Access Compliance Report

Public Rights-of-Way

Intersection ID: 22202	Main Street: E_HEBRON_ST	Cross Street: HEBRON_COMMERCE_DR	Location: SE
ADA ID: 0715092EC178	Ramp Type: BlendTrans2	Initial Pass/Fail: Pass	Overall Compliance: No
Severity Score: 5			
Codes/Mitigation Info/Possible Solution		Field Measurements/Component Compliance

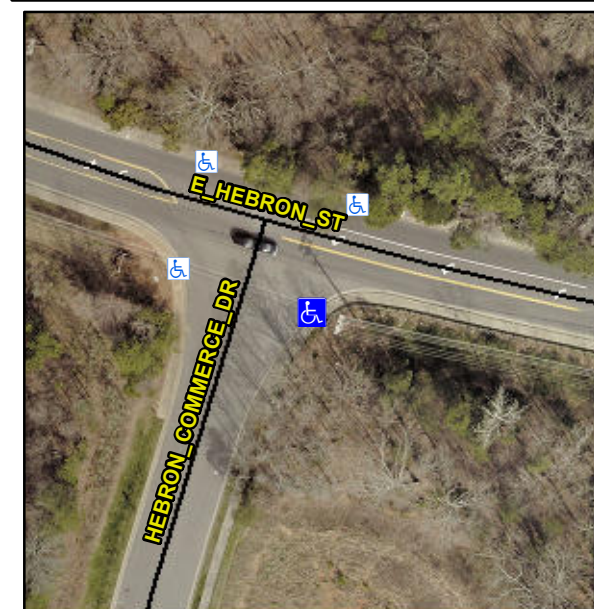
R304.2.3, R304.5.4

Compliance	Description	Data	Compliance	Description	Data
N/A	Ramp Length (in)	58.0	Yes	BlendTrans Slope (%)	1.3
Yes	Ramp Width (in)	48.0	Yes	BlendTrans XSlope (%)	1.0
N/A	Flare Type LT	Sloped	N/A	Flare Type RT	Sloped
No	Flare Slope LT (%)	N/A	No	Flare Slope RT (%)	N/A
N/A	Flare Traversable LT?	Yes	N/A	Flare Traversable RT?	Yes
N/A	Landing Length (in)	N/A	Yes	DWS Provided?	Yes
N/A	Landing Width (in)	N/A	Yes	DWS Contrast?	Yes
N/A	Landing Slope (%)	N/A	Yes	DWS Length (in)	24.5
N/A	Landing X Slope (%)	N/A	Yes	DWS Full Width?	Yes
N/A	Landing Curb? (Y/N)	No	Yes	DWS Offset (in)	0.0
N/A	Shared Landing?	No			
Yes	Gutter Ponding?	No	No	Gutter Slope (%)	14.9
Yes	Gutter Lip Ht (in)	0.0	Yes	Gutter X Slope (%)	0.3
N/A	Painted X Walk1?	No	N/A	Painted X Walk2?	No
	X Walk 1 Direction	To N		X Walk 2 Direction	To NW
	X Walk 1 Width (in)	N/A		X Walk 2 Width (in)	N/A
	X Walk 1 Slope (%)	0.8		X Walk 2 Slope (%)	6.9
	X Walk 1 X Slope (%)	10.3		X Walk 2 X Slope (%)	1.8

N/A	Ramp inside XWalk1?	N/A	N/A	Ramp inside XWalk2?	N/A
	Road Slope (%)	1.8		Clear Space?	Yes
	Road X Slope (%)	9.7	N/A	Clear Space to XWalk (in)	N/A
Yes	Any Obstructions?	No	Yes	Storm Grate/Utility Hazard?	No
	Obstruction Type			Storm Grate/Utility Type	
		N/A			N/A
			Yes	Surface Condition? (G/P)	Good
			Yes	Curb Slope (%)	2.1

Remove & Replace Curb Ramp With Two New Directional Ramps or Equivalent. Remove & Replace Gutter.
